TOWN OF GLASTONBURY

BID #GL-2011-22

**Buttonball Lane School
Boiler Replacement
Glastonbury, CT**

ADDENDUM #1

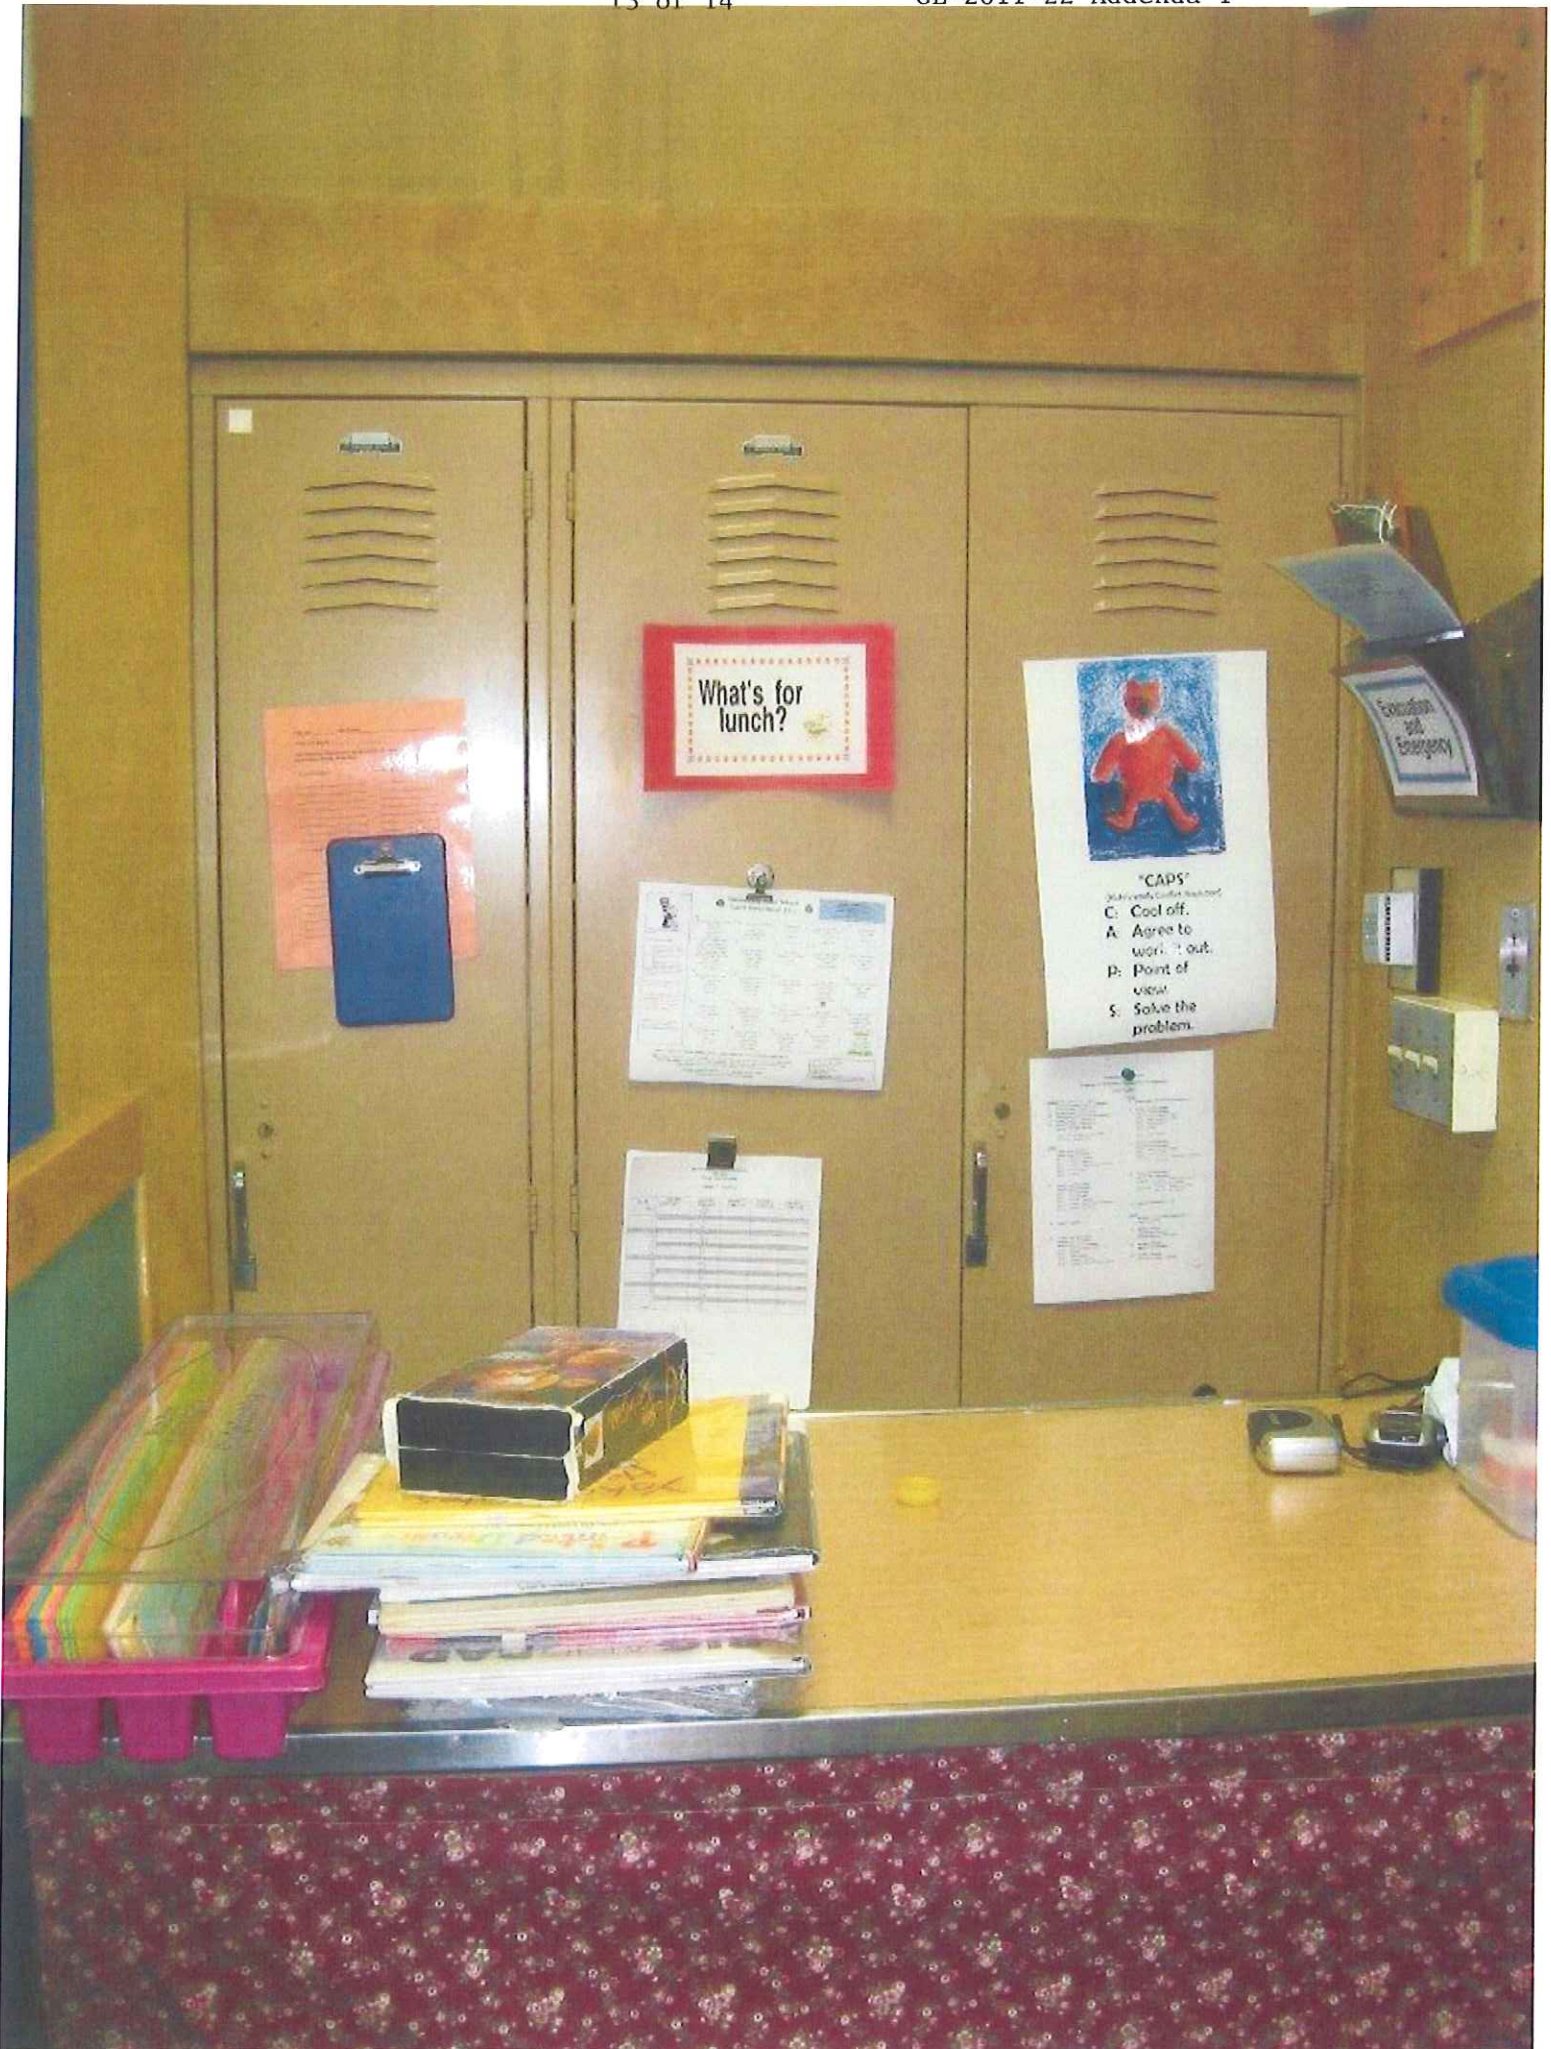
20. Question: Drawings A1.00 note #3 calls to remove a locker and replace it with one which is in the next room. How many lockers does this happen to and are we to remove the lockers from the next room? What do you replace that space with, a locker, drywall etc? Please clarify how to finish off these areas and provide details for these lockers and their areas.

Answer: Drawing A1.00 note #3 is shown in rooms 121 and 123. See attached photo for reference.
